Columbia County Building Permit

Re: Foundation Inspection, Will & Jessica Myers Residence, 693 Hamlet Circle, Lot 9, Unit 3, Southwood Acres, Lake City, Florida 32024, 36-4S-16-03373-009, Columbia County, FL

This letter is in reference to a foundation inspection issue for Will & Jessica Myers Residence, 693 Hamlet Circle, Lot 9, Unit 3, Southwood Acres, Lake City, Florida 32024, 36-4S-16-03373-009, Columbia County, FL, Windload Engineering Job No. MD503222.

REF	R487 - -	73964
DATE	09/09/05	
DRW	HCUSR487	05252089
HC-ENG	DF / AF	
SEQN-	118512	
FROM	SA	
JREF-	150B487	Z05

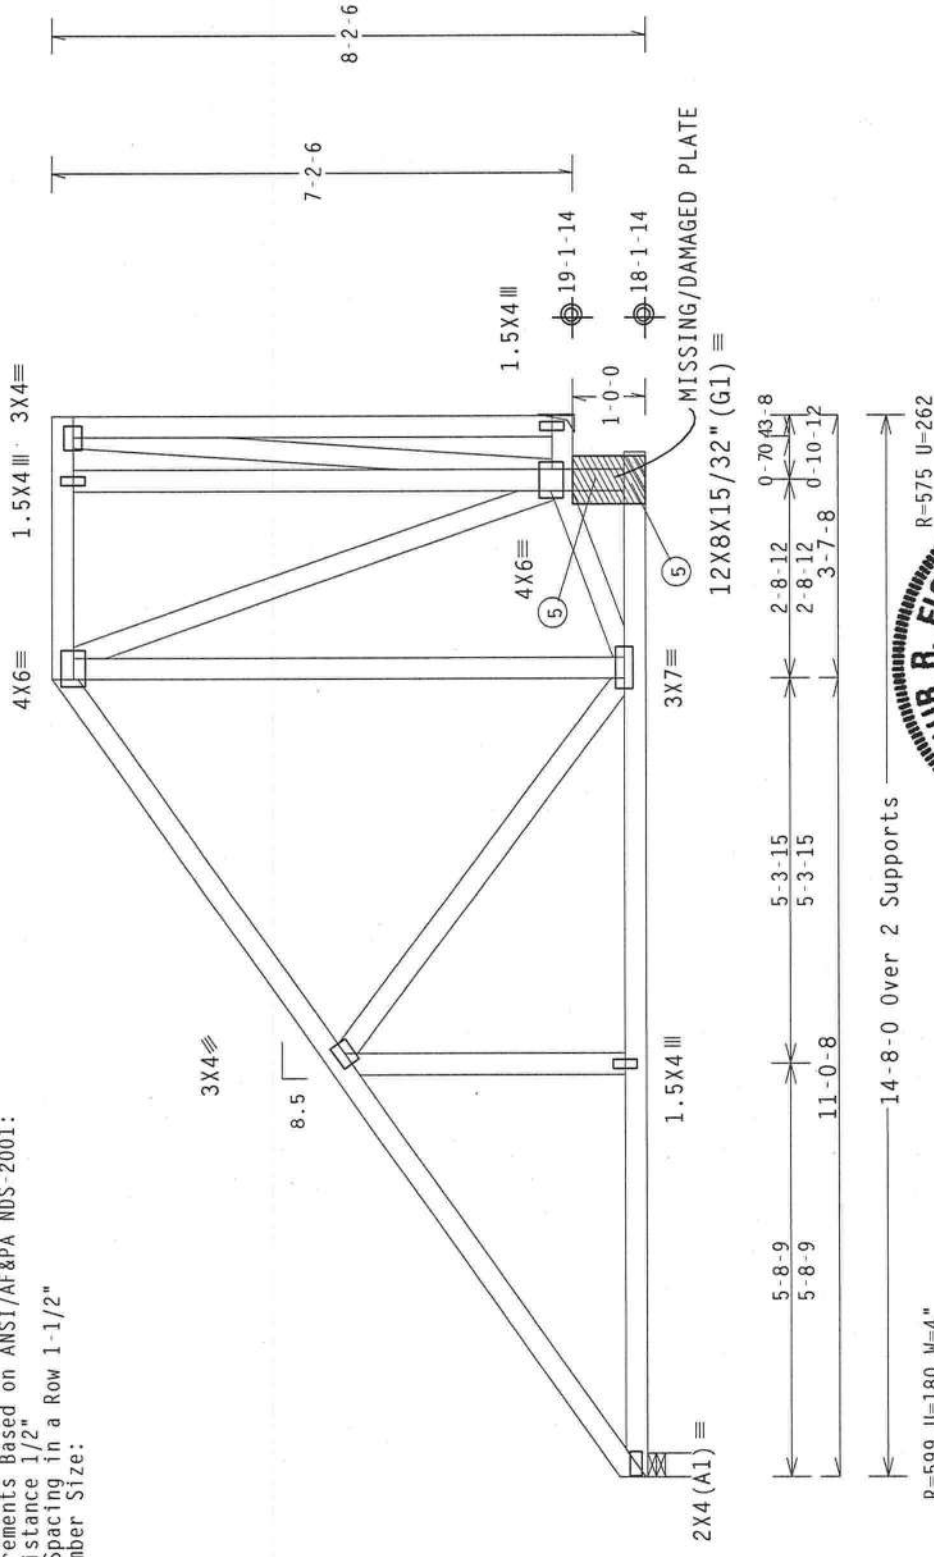
THIS TRUSS IS REPAIRED FOR A MISSING/DAMAGES PLATE.
FIELD REPAIR MUST COMPLY WITH ALPINE DESIGNS AND SPECS.

(G1) Gusset Plates are 15/32" APA RATED SHEATHING, 24/0, EXP 1 or 2. Apply gusset to each face of truss and attach with evenly distributed 6d Box (0.099x2.0") Nails specified in circles.
Minimum Nail/Screw Spacing Requirements Based on ANSI/AF&PA NDS-2001:
End Distance 1-1/2" Edge Distance 1/2"
Spacing Between Rows 1/2" Spacing in a Row 1-1/2"
Maximum Number of Rows for Member Size:
2x4 5 Rows

REPAIR WORK SHOWN ON THIS DRAWING APPLIES ONLY TO THOSE SECTIONS OF THE TRUSS REPORTED BY THE TRUSS MANUFACTURER TO HAVE BEEN DAMAGED. A QUALIFIED THIRD PARTY INSPECTOR SHALL CHECK TRUSSES TO DETERMINE THE EXTENT OF ANY FURTHER DAMAGE, IF ANY, AND VERIFY THAT REPAIRS HAVE BEEN PERFORMED AS INDICATED ON THIS DRAWING.
